Planning and Strategy Committee

Adoption of the Sandy Bay Landscape Masterplan

**Draft Sandy Bay Landscape Masterplan
Public Exhibition Submissions & Staff Response September 2010**

**PROPOSED REMOVAL OF PINE STREET STORMWATER PIPE –
IMPACT ON BEACH PROCESSES**

Figure 1: Wave Data Offshore Sydney (08/10/10 to 11/10/10) Long Reef Wave Rider Buoy (Manly Hydraulics Laboratory
http://www.mhl.nsw.gov.au/htbin/wave_data_plot.com?Location=Sydney)

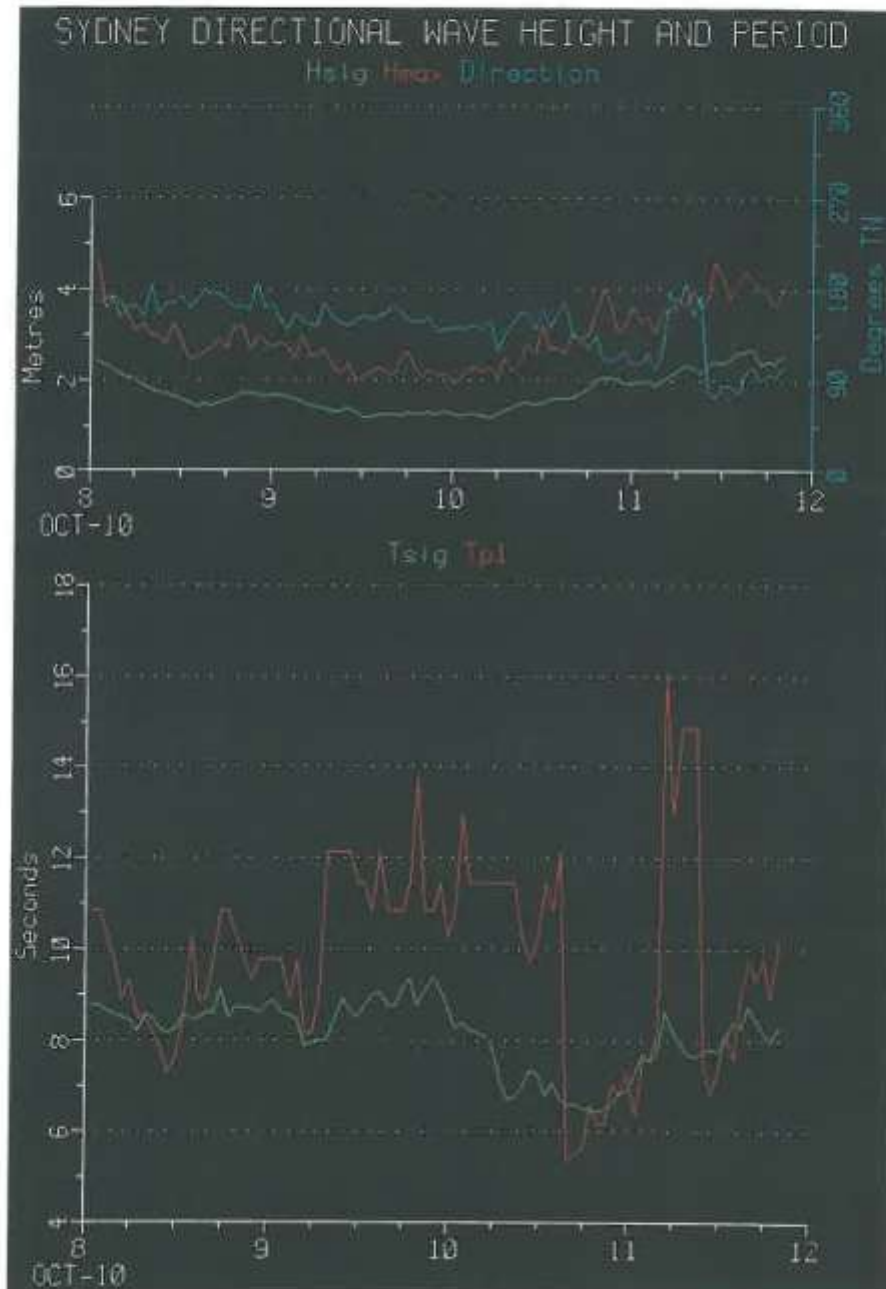
Photographs 1 and 2 were taken during site visit 1 and photographs 3, 4 and 5 during site visit 2. During these site inspections the offshore wave conditions were about 1.5m significant wave height from the south-east and peak period of $T_p=10s$, which represent the mean wave conditions offshore Sydney (see Figure 1) – Long Reef offshore Waverider buoy (MHL).
